SESA PUERTO RICO**NEPR****Received:****Feb 10, 2025**
5:30 PM**Input regarding real-world impact of new Smart Inverter Settings since going into effect January 1st, 2025, and Request for Urgent Modifications to required Smart Inverter Settings****Docket: NEPR-MI-2019-0009, INTERCONNECTION REGULATIONS**

February 10th, 2025**Executive Summary**

- Similarly, the below table shows the amount of time that new Enphase systems deployed in 2025 have spent above the indicated voltage levels:

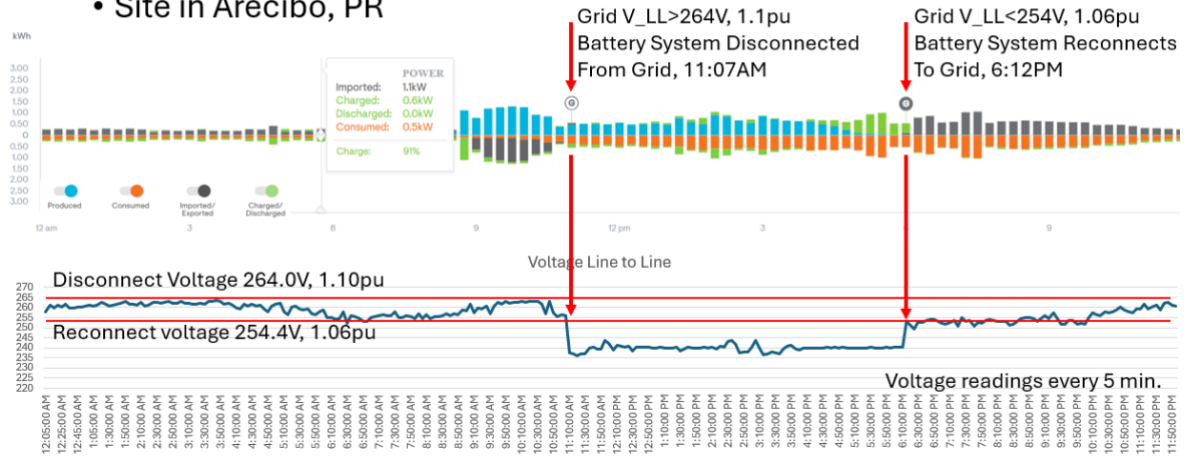
- LUMA's required **voltage enter service maximum value** is set to **1.06 PU (127.2 V)**. This has proven to be too low, leading to unnecessary, sustained DER shutdowns in high-voltage areas.
- DER Tripping occurs when the voltage rises above **1.1 PU (132.00 V)**. In high voltage parts of the grid, where the voltage is routinely above **1.06 PU (127.2 V)**, the inverters will never enter

- Enphase has collected the following maximum voltage statistics on new sites that were deployed in 2025, showing that more than half of new systems have recorded max voltages above 106 p.u.:

- Increase enter service maximum value for voltage from **1.06 PU (127.2 V)** to **1.10 PU (132 V)** to allow faster resumption of service.
- Implement reconnection criteria that enable inverters to resume operation without excessive delays.
- SESA recommends the following changes to PREB's requirements:

A. Frequency Droop Deadband

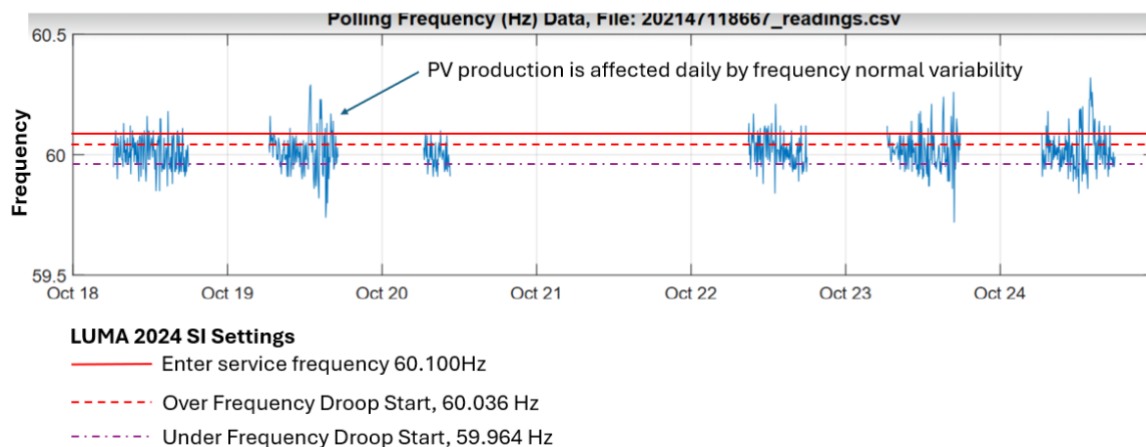
LUMA's smart inverter requirements did not specify Frequency Droop (a.k.a. Frequency-Watt or FW) settings. Without such guidance, industry applied the IEEE 1547:208 default values. These default values have a very narrow deadband limit of 0.036 Hz (36 mHz) for the Frequency-Droop function, even though

the IEEE 1547:2018 standard presents a wider range of allowable deadband settings, from 0.017 Hz to 1 Hz. The default deadband of 0.036 Hz is small and should only be used when operating within very stable grids, such as those on the mainland. Island communities, such as Hawaii, Virgin Islands, and Puerto Rico, do not have the luxury of a high inertia grid producing stable grid frequency. It's important to allow higher deadband settings to maintain DER connectivity and power production in a low inertia grid.

- Increase the Frequency-droop deadband from 0.036 Hz (36 mHz) to 0.250 Hz (250 mHz).
- Enphase data indicates that this should help most sites sustain power production, for most of the time.

Example Enphase Site in Ciales, PR

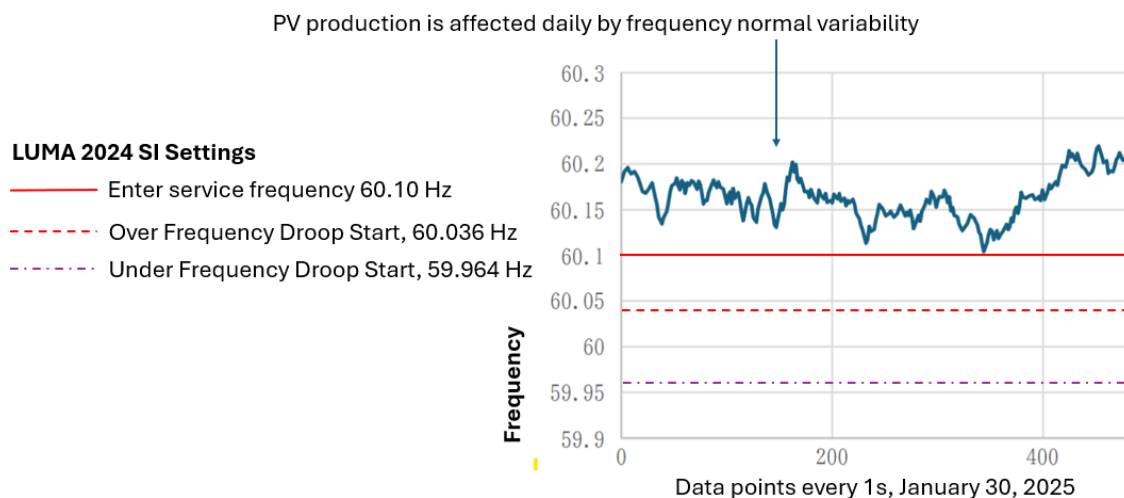
- Enphase has measured the frequency at several sites, and they have found the frequency is often outside of the IEEE 1547-2018 default deadband. This situation is particularly sensitive when a system enters service either at the start of the day or after a DER trips offline. If the frequency is outside the deadband, as is often the case, the DER will not produce power until the frequency returns into the deadband region.
- The below shows frequency data for a representative Enphase site:

- The effect of the narrow default frequency deadband is that, for extended periods of time, the inverter cannot produce power due to frequency instability.
